TECHNICAL INFORMATION JDE

Type Coffee Vending Machine	Model 9100	T.I. NO 03 - 2017	
Serial Number 65111208	Subject New Fastening CLIPS for Liquid Basin Aluminium Profile	ISSUED FOR (X)	Action Information X

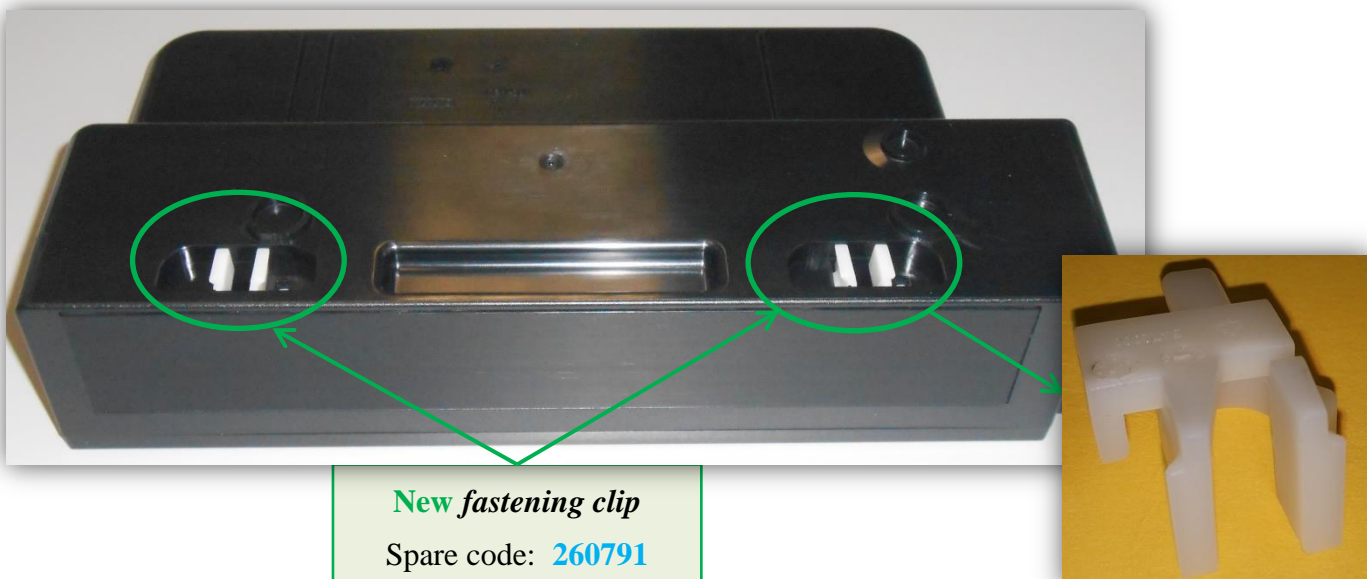
For the liquid basin cleaning it's recommended to separate the *basin aluminium profile* from the *plastic liquid basin*, when the *basin* is washed by dishwasher.

It's required a quicker removal of the *basin aluminium profile* from the *liquid basin*.

The liquid basin has been modified to create the **new fastening clips** housing.

The fastening clips allow to fix and remove quickly the *basin aluminium profile* from the *basin*.

New *basin aluminium profile*
Spare code: **261204**

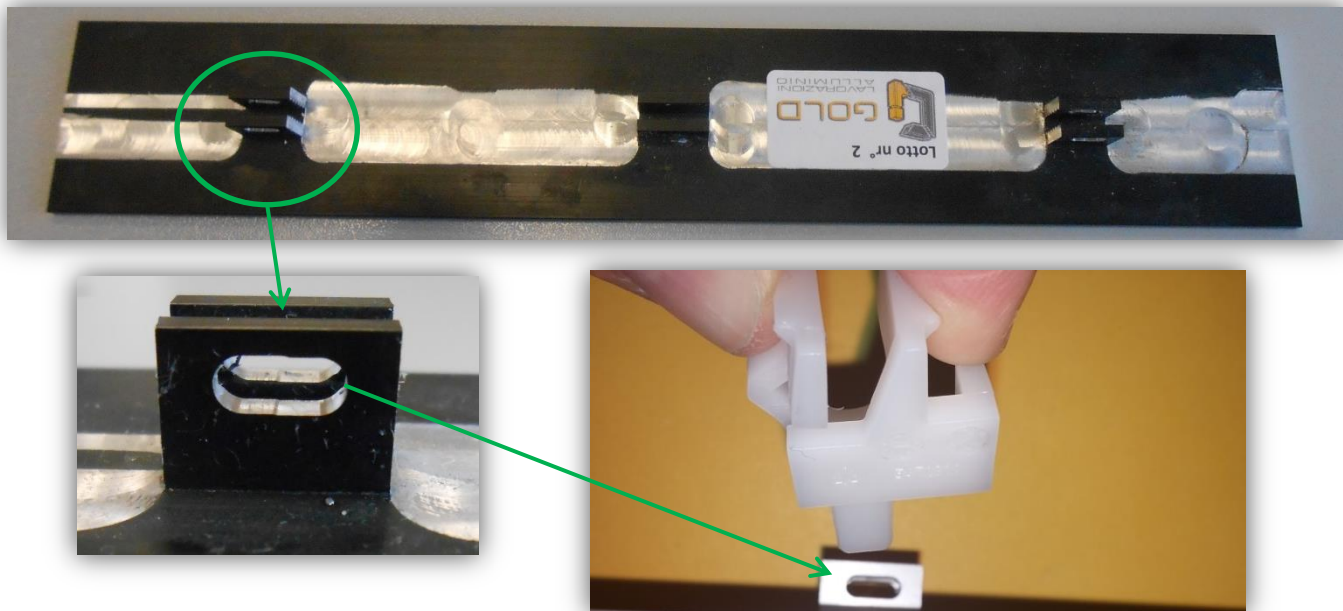
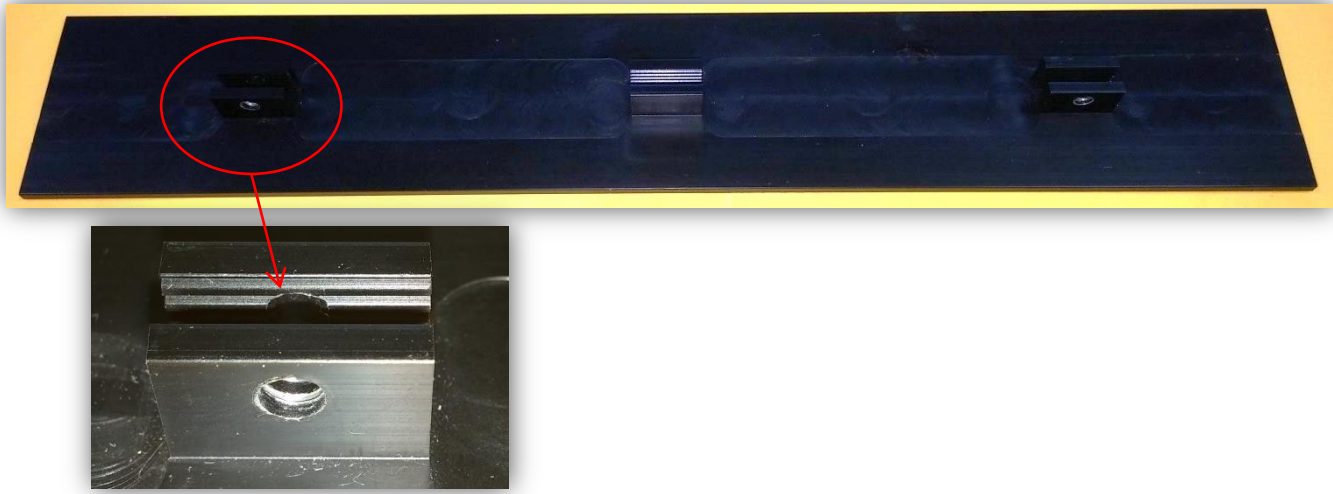
The *basin aluminium profile* has been modified to join the *fastening clips*.

Pre-modification *basin aluminium profile*
Spare code: **260489**

New solution
Handle fixing / release

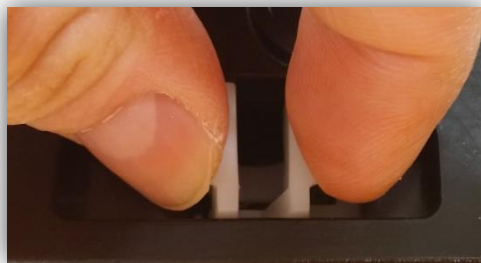
Pre-modification solution
Fixing/release by screwdriver

Screw inserted in the holes on the aluminium profile
